Manual Supplement

Manual Title:	27 Service	Supplement Issue:	2
Part Number:	690206	Issue Date:	7/99
Print Date:	November 1998	Page Count:	2
Revision/Date:

Figure A.

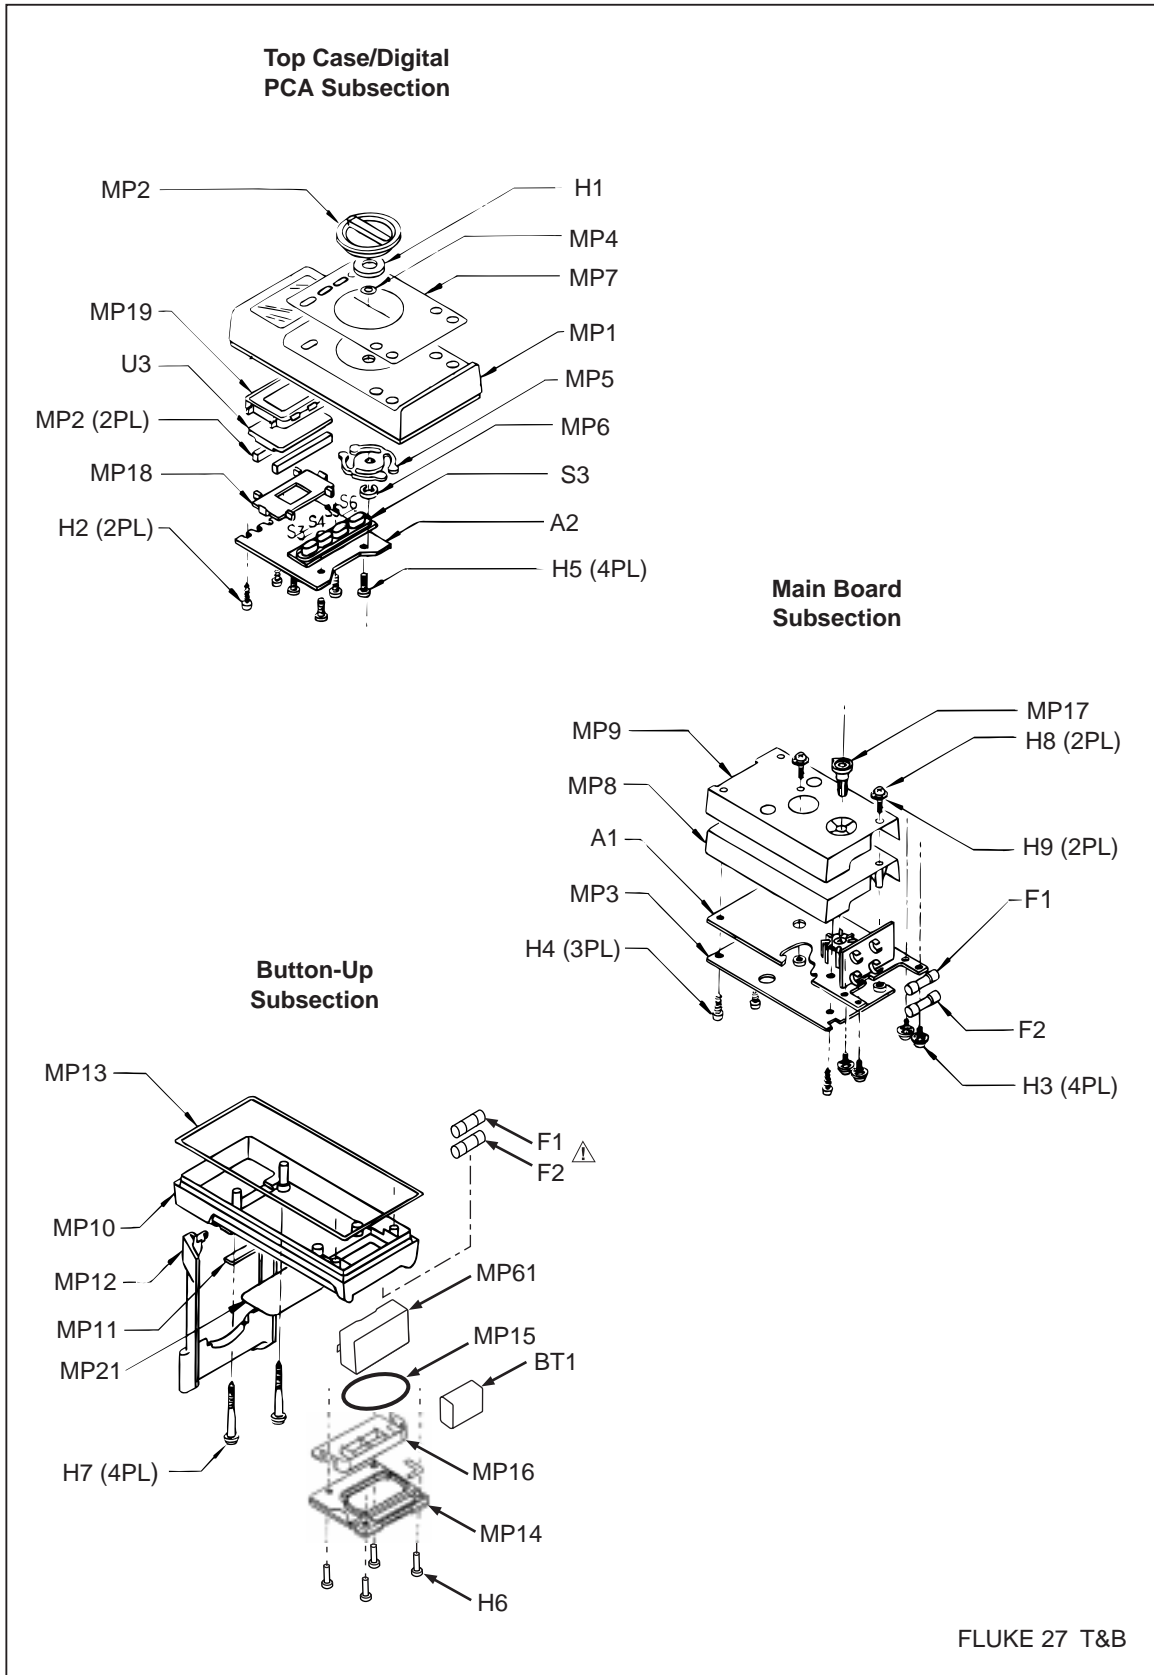
On pages 3-8 and 4-7, Figures 3-2 and 4-1, change the view of MP16 as shown in Figure A.
